ARCHITECTURAL REVIEW BOARD STAFF REPORT

Project #/Name	SP-2023-07: The Home Depot Outdoor Storage Display Sales
Review Type	Advisory Review for a Special Use Permit
Parcel Identification	06100000013200
Location	1531 Rio Road East (Fig. 1)
Zoned	Planned Development Shopping Center (PDSC), Entrance Corridor (EC), Airport Impact Area (AIA), Managed Steep Slopes
Owner/Applicant	Home Depot USA Inc./Williams Mullen (Valerie Long)
Magisterial District	Rio
Proposal	To establish outdoor storage, display and sales of lawn, garden and related merchandise in association with the construction of a Home Depot store at the former location of the Sears store at the Fashion Square Mall property.
Context	The project is located at the north end of the Fashion Square Mall. A mix of commercial and office buildings is found nearby.
Visibility	The garden center is located adjacent to the Rio East Entrance Corridor. The street is elevated above the site. Some mature trees and shrubs stand along the street and entrance drive, but views are available between the trees and through gaps in the landscaping, and visibility increases during the winter months. The view from Rio will be down into and over the gar

Figure 4: Home Depot Plan with outdoor display areas highlighted.

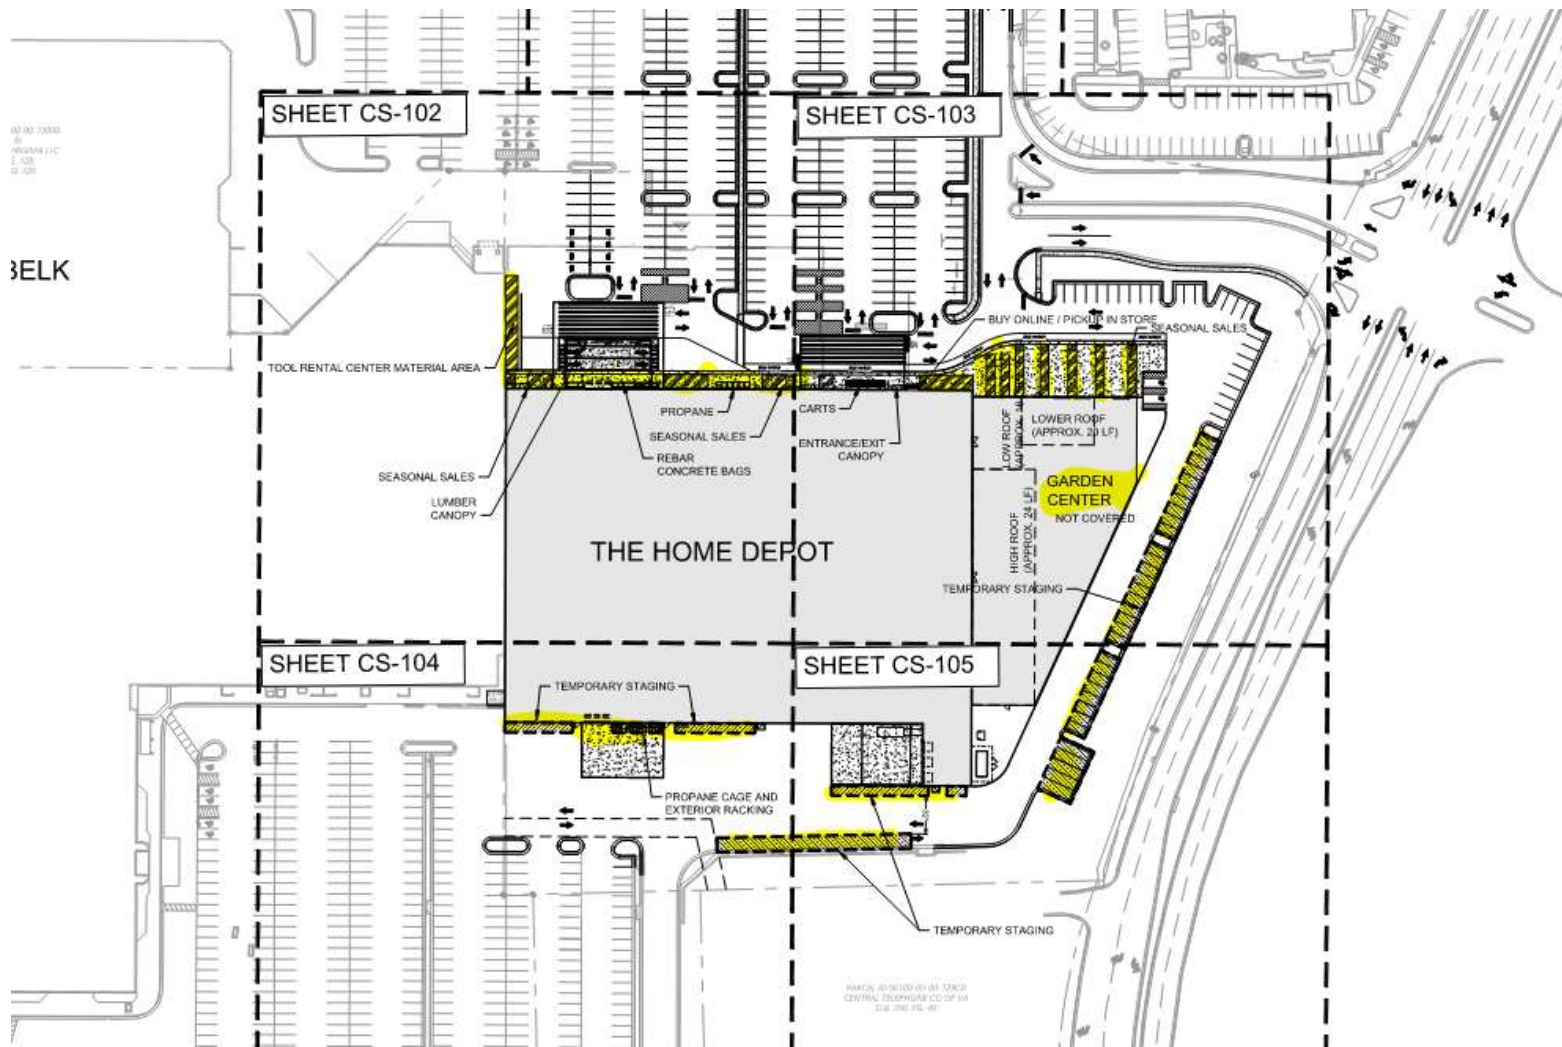
PROJECT DETAILS (Fig. 4)

The proposal includes the storage, display, and sale ("display") of garden and related merchandise in an open-air, partially roofed Garden Center and in various locations outside the building.

- Proposed display items outside the store include plants displayed on tables and racks, lawn mowers, grills, wheelbarrows, snow blowers and similar/related items, as well as customer pick-up lockers, propane exchange cabinets, building materials under the lumber pick-up canopy, and a Tool Rental Center area. **VISIBILITY:** Display items on the Rt. 29 side of the building will be visible from the Rt. 29 corridor, though at a distance. Those items will also have some visibility from Rio Rd., particularly at the entrance into the site, though existing and proposed landscaping will break up the view.

- The proposed Garden Center is partially roofed and partially open to the sky. Products housed in the Garden Center include plants, mulch, building materials and other similar items. **VISIBILITY:** With existing landscaping, views will be available down into and over the garden center from Rio Rd. (It is estimated that the garden center is about as tall as the Sears building, and the main Home Depot building is somewhat taller.) The Garden Center will be visible from Rt. 29, but at a distance.

- Temporary staging areas for the storage of items including mulch, stone, soil and other similar products, and lumber deliveries are proposed in the portion of the parking lot along Rio Road and behind the building. **VISIBILITY:** These areas are not expected to be visible from the EC streets.
